The Commission has issued the enclosed Amendment No. 6, Technical Specification Change No. 16 for License No. DPR-38; Amendment No. 6, Technical Specification Change No. 11 for License No. DPR-47; and Amendment No. 3, Technical Specification Change No. 3 for License No. DPR-55, for the Oconee Nuclear Station, Units 1, 2, and 3. These amendments are in response to your request dated September 20, 1974, and subsequent letters dated October 8, 1974, and October 31, 1974.

DUKE POWER COMPANY

OCONEE NUCLEAR STATION, UNIT 1

AMENDMENT NO. 6 TO FACILITY LICENSE NO. DPR-38,
CHANGE NO. 16 TO TECHNICAL SPECIFICATIONS;

Figure 2.1-1A | 16/11/3

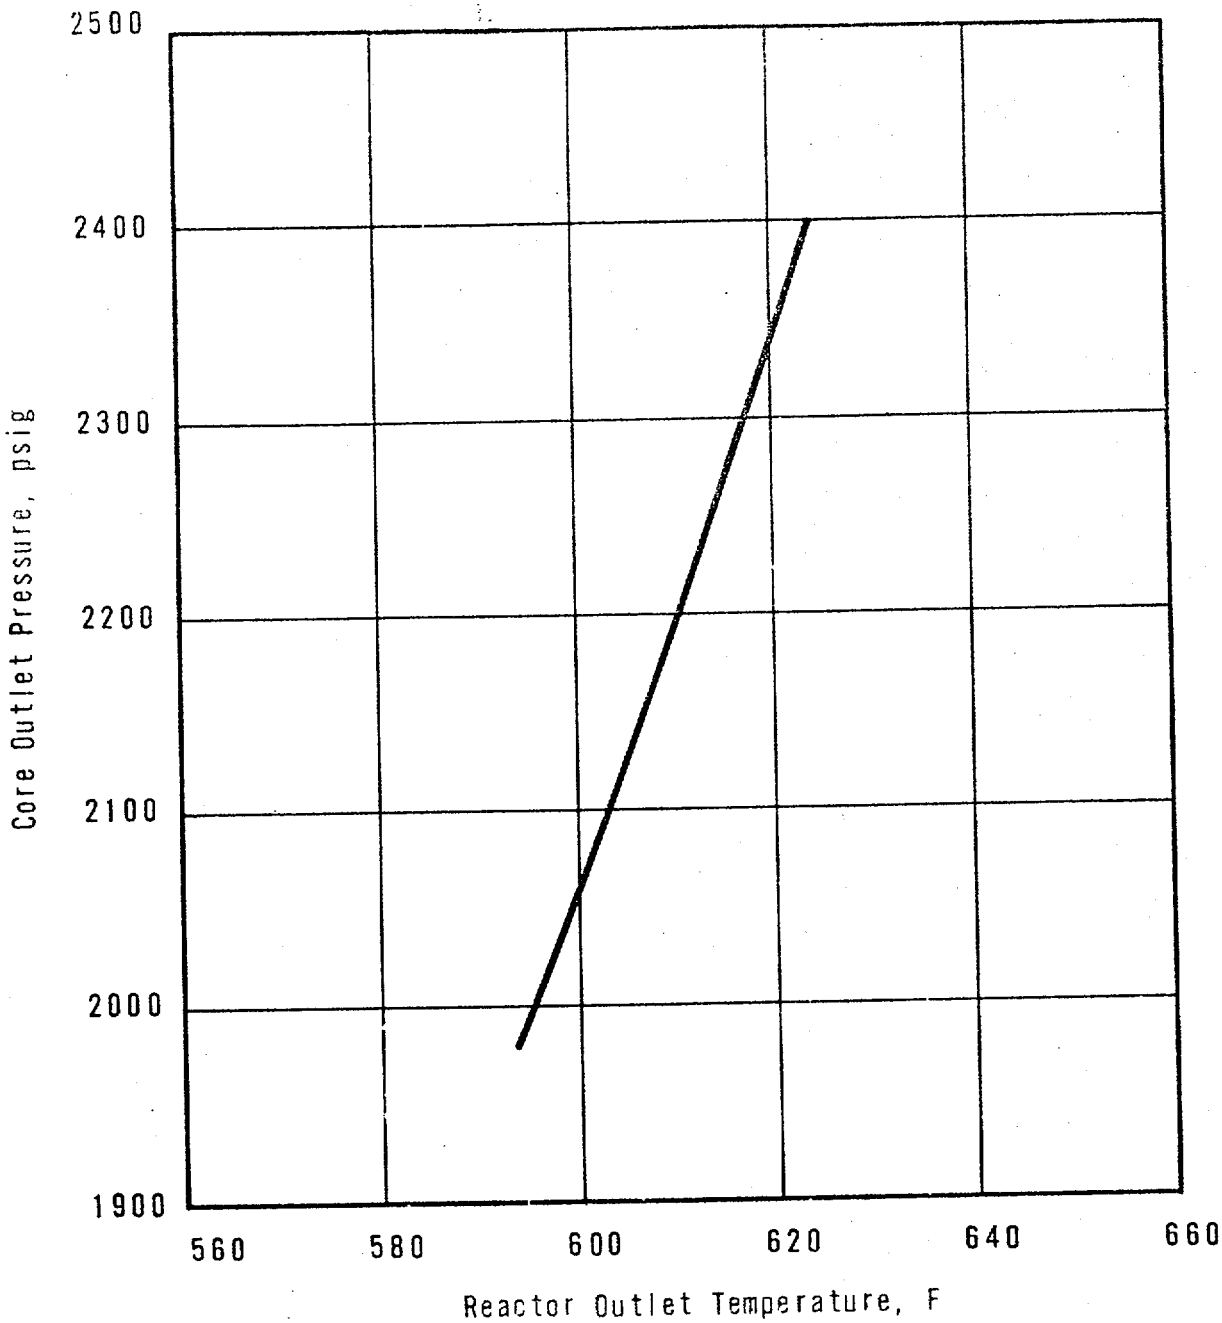
The combination of the reactor system pressure and coolant temperature shall not exceed the safety limit as defined by the locus of points established in Figure 2.1-1A-Unit 1. If the actual pressure/temperature point is below
2.1-1B-Unit 2
2.1-1C-Unit 3
and to the right of the line, the safety limit is exceeded.

The curve presented in Figure 2.1-1A represents the conditions at which a minimum DNBR of 1.32 is predicted for the maximum possible thermal power (112 percent) when four reactor coolant pumps are operating (minimum reactor coolant flow is 107.6 percent of 131.3 x 10^6 lbs/hr.). This curve is based on the combination of nuclear power peaking factors, with potential fuel densification effects, which result in a more conservative DNBR than any other shape that exists during normal operation.

The curve of Figure 2.1-1A is the most restrictive of all possible reactor coolant pump-maximum thermal power combinations shown in Figure 2.1-3A (because the four-pump pressure - temperature restriction is known to be more limiting than the 3 and 2 pump combinations, only the four pump limit has been shown on Figure 2.1-3A).

Figure 2.1-2A

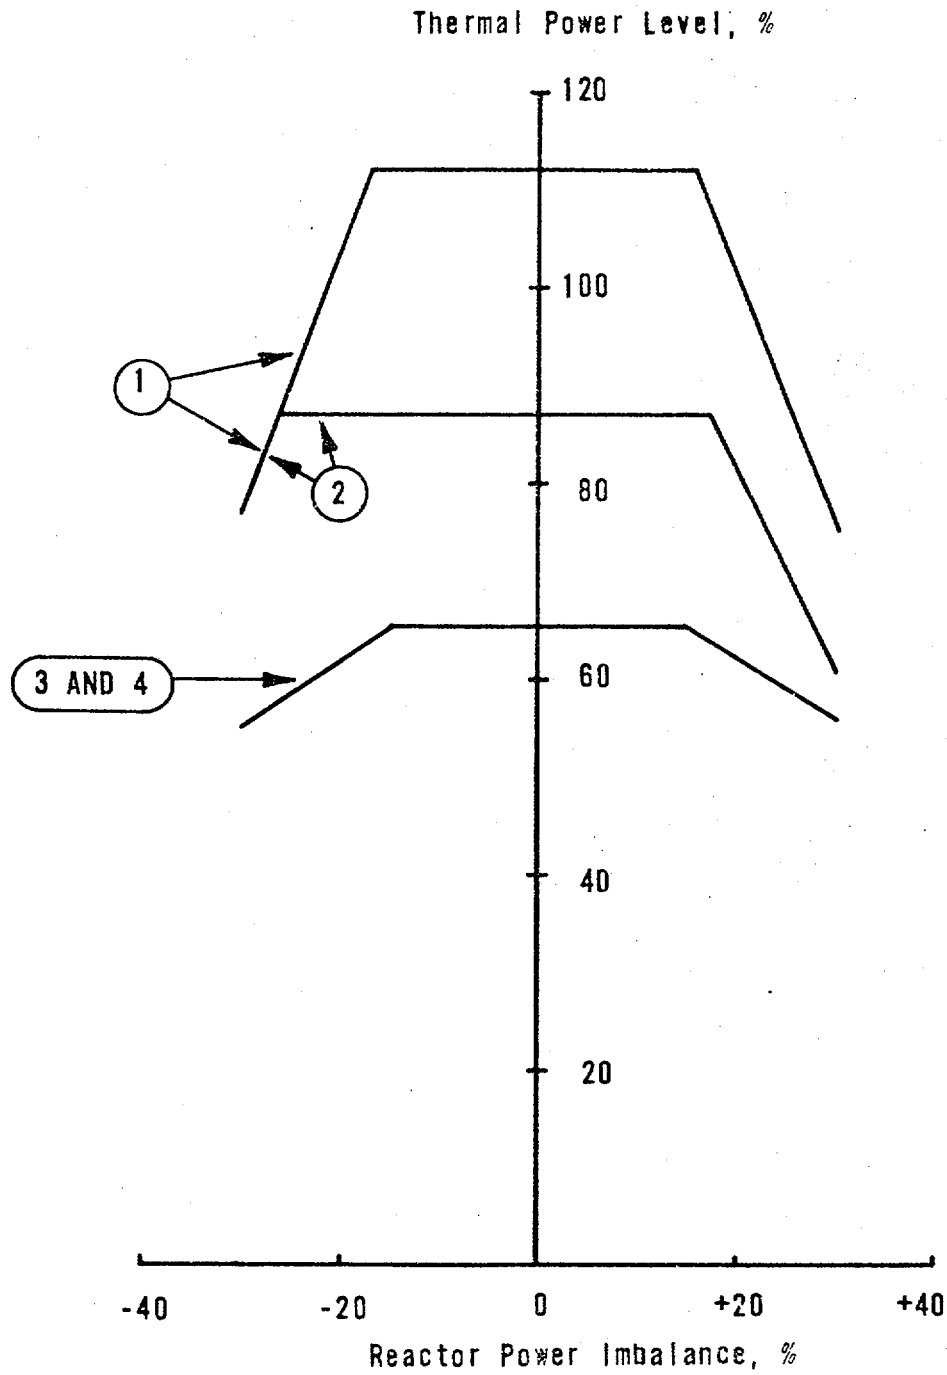
The curves of Figure 2.1-2A are based on the more restrictive of two thermal limits and include the effects of potential fuel densification:

The specified flow rates for Curves 1, 2, 3 and 4 of Figure 2.1-2A correspond to the expected minimum flow rates with four pumps, three pumps, one pump in each loop and two pumps in one loop, respectively.

Figure 2.1-3A | 16/11/3

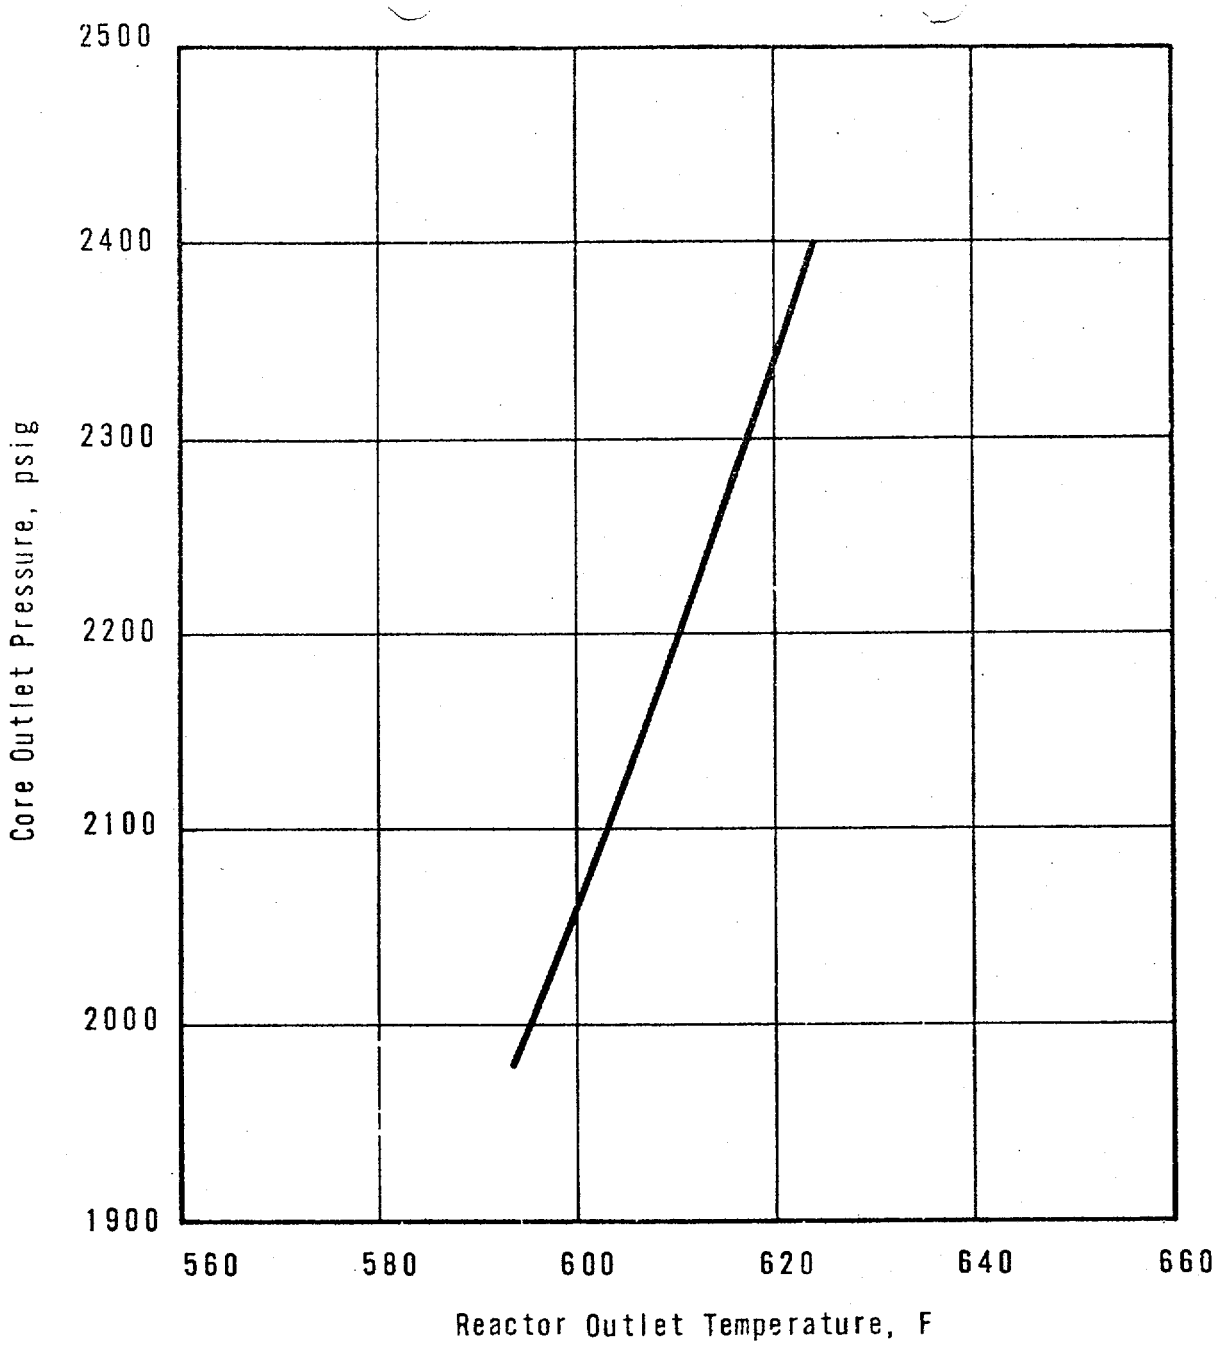
For Figure 2.1-3A, a pressure-temperature point above and to the left of the curve would result in a DNBR greater than 1.32. The 1.32 DNBR curve for four-pump operation is more restrictive than any other reactor coolant pump situation because any pressure/temperature point above and to the left of the four pump curve will be above and to the left of the other curves.

OCONEE NUCLEAR STATION
Figure 2.3-1A 16/11/3

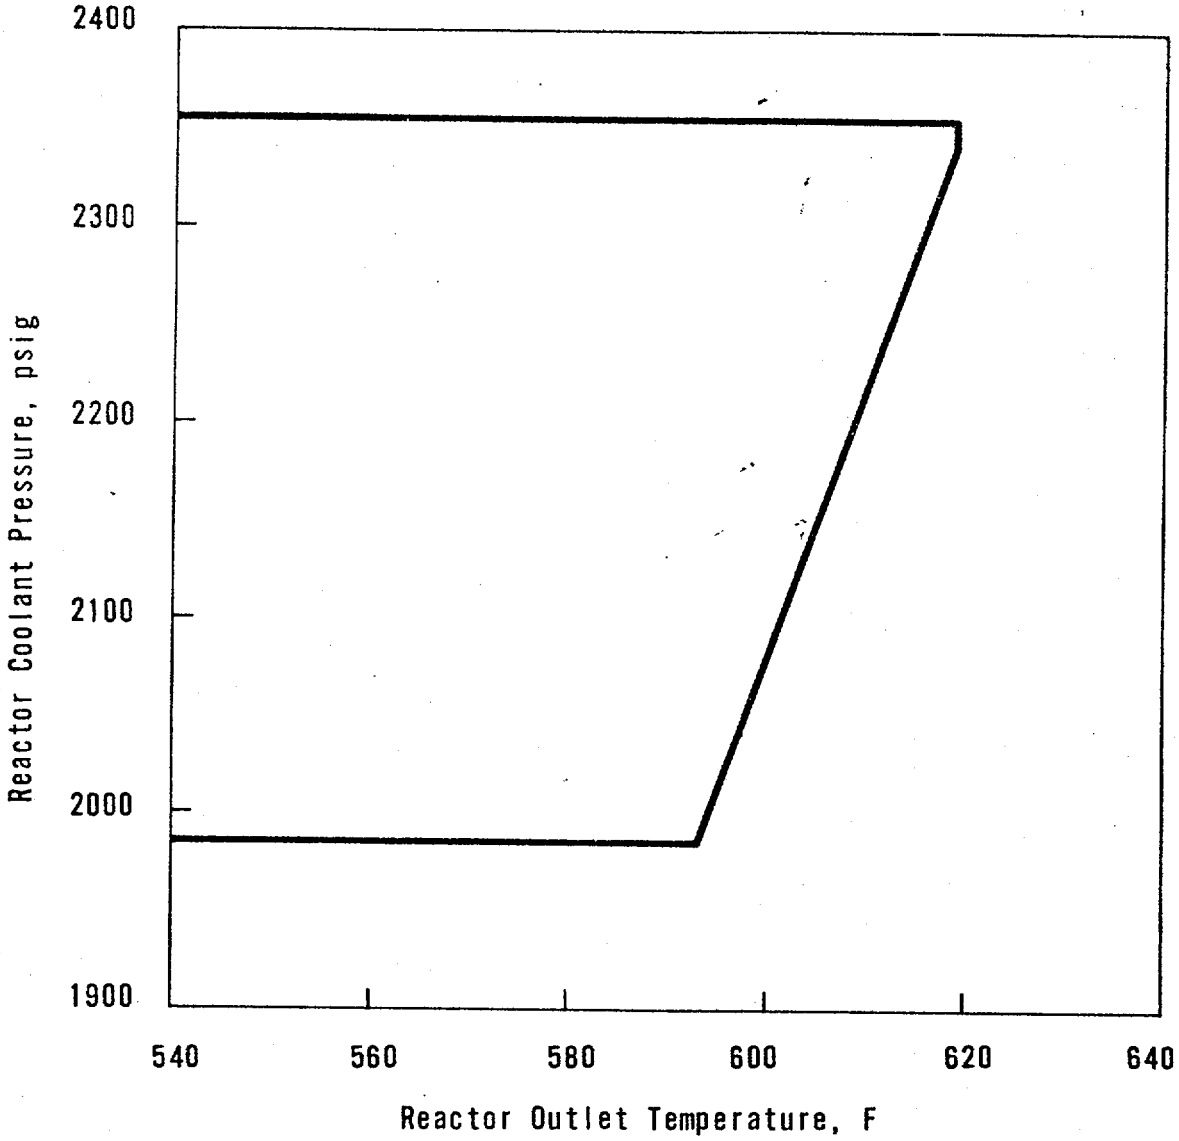
During a startup accident from low power or a slow rod withdrawal from high power, the system high pressure set point is reached before the nuclear overpower trip set point. The trip setting limit shown in Figure 2.3-1A - Unit 1
2.3-1B - Unit 2
2.3-1C - Unit 3
for high reactor coolant system pressure (2355 psig) has been established to maintain the system pressure below the safety limit (2750 psig) for any design transient.(1)

The low pressure (1985) psig and variable low pressure ($13.77\ T_{out} - 6181$) trip 16/11/3
(1800) psig ($16.25\ T_{out} - 7756$)
(1800) psig ($16.25\ T_{out} - 7756$)
setpoints shown in Figure 2.3-1A have been established to maintain the DNB
2.3-1B
2.3-1C
ratio greater than or equal to 1.3 for those design accidents that result in a pressure reduction.(2,3)

The high reactor coolant outlet temperature trip setting limit (619 F) shown in Figure 2.3-1A has been established to prevent excessive core coolant
2.3-1B
2.3-1C
temperatures in the operating range. Due to calibration and instrumentation errors, the safety analysis used a trip set point of 620°F.

Figure 2.3-2A2 | 16/11/3

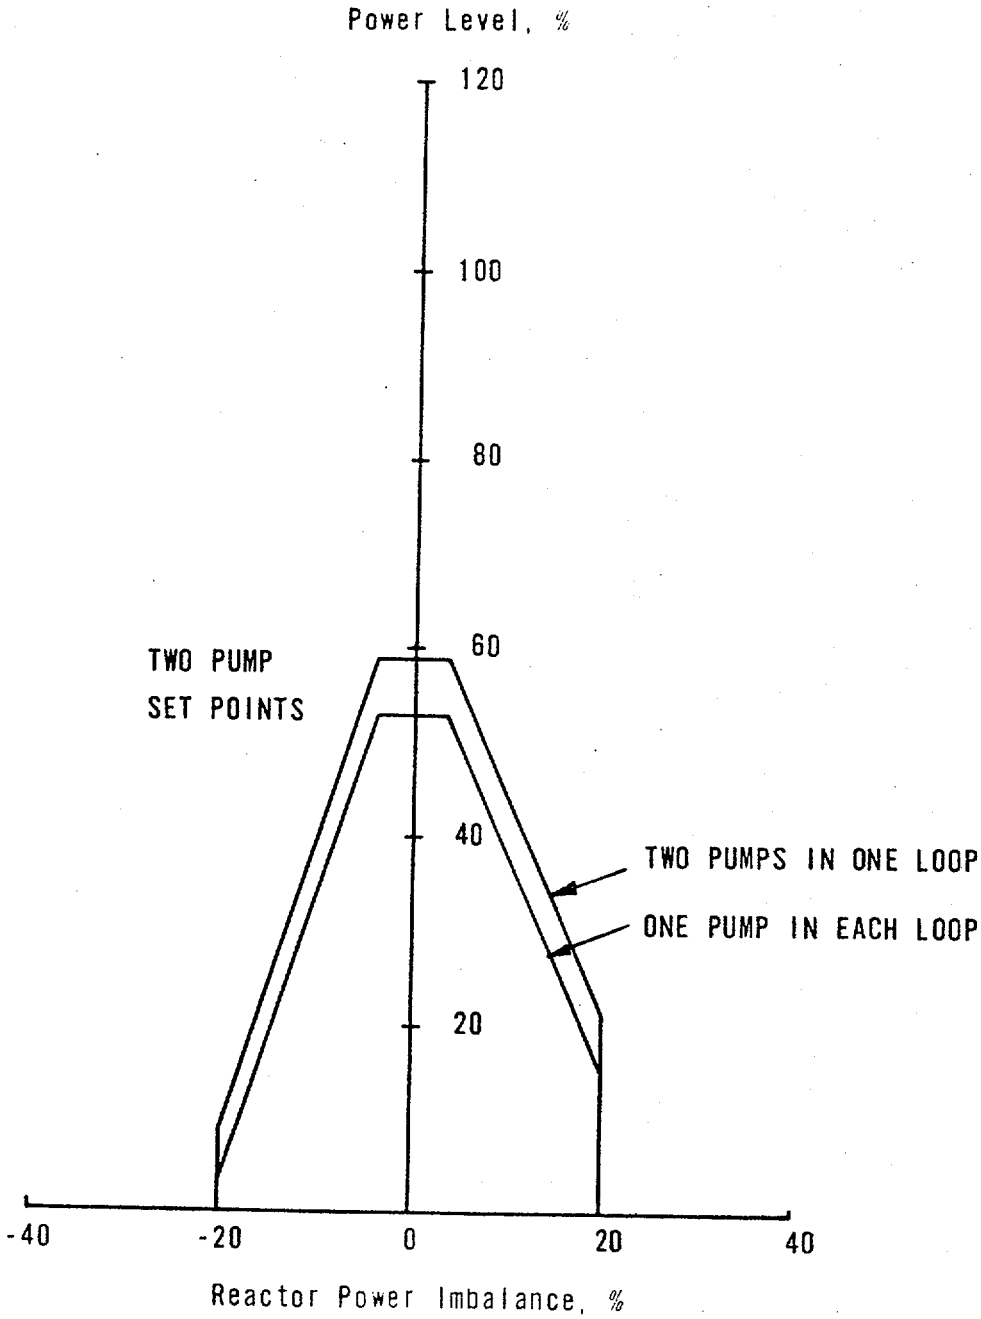
Operation with one pump in each loop will be allowed only following reactor shutdown. After shutdown has occurred, the following actions will permit operation with one pump in each loop:
1. Reset the pump contact monitor power level trip setpoint to 55.0%.
2. (Unit 1) Reset the protective system maximum allowable setpoint as shown in Figure 2.3-2A2.

Figure 3.5.2-1A1 | 16/11/3

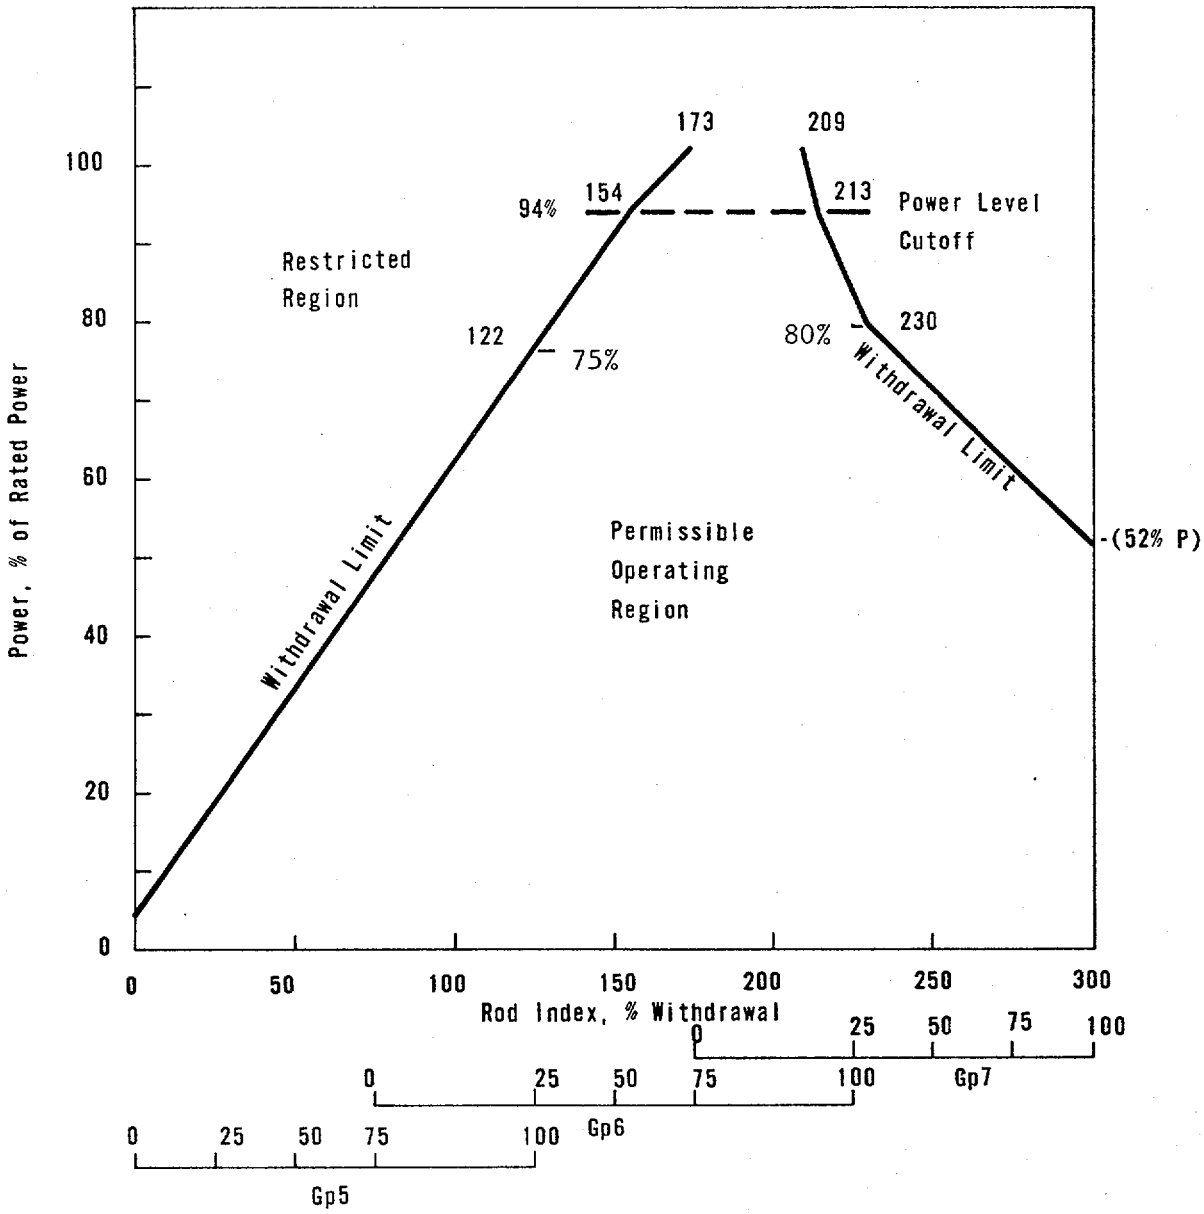
These amendments include the Technical Specification changes required for the second fuel cycle operation of Oconee Unit 1. The proposed Control Rod Withdrawal Limit For 4 Pump Operations (Figure 3.5.2-1A2) after 250 ± 5 full power days of operation has not been included in this change since it does not conform to the Interim Acceptance Criteria for ECCS and your proposed Final Acceptance Criteria (Appendix K) Technical Specifications have not yet been approved.

d. Except for physics tests, power shall not be increased above the power level cutoff as shown on Figure 3.5.2-1A1 (Unit 1), 3.5.2-1B1, 3.5.2-1B2, and 3.5.2-1B3 (Unit 2), and 3.5.2-1C1, 3.5.2-1C2, and 3.5.2-1C3 (Unit 3), unless the following requirements are met. 16/11/

2. These withdrawal limits are effective only for 250 ± 5 full power days of operation after issuance of Amendments No. 6, 6 and 3, respectively, of Licenses No. DPR-38, -47, and -55.
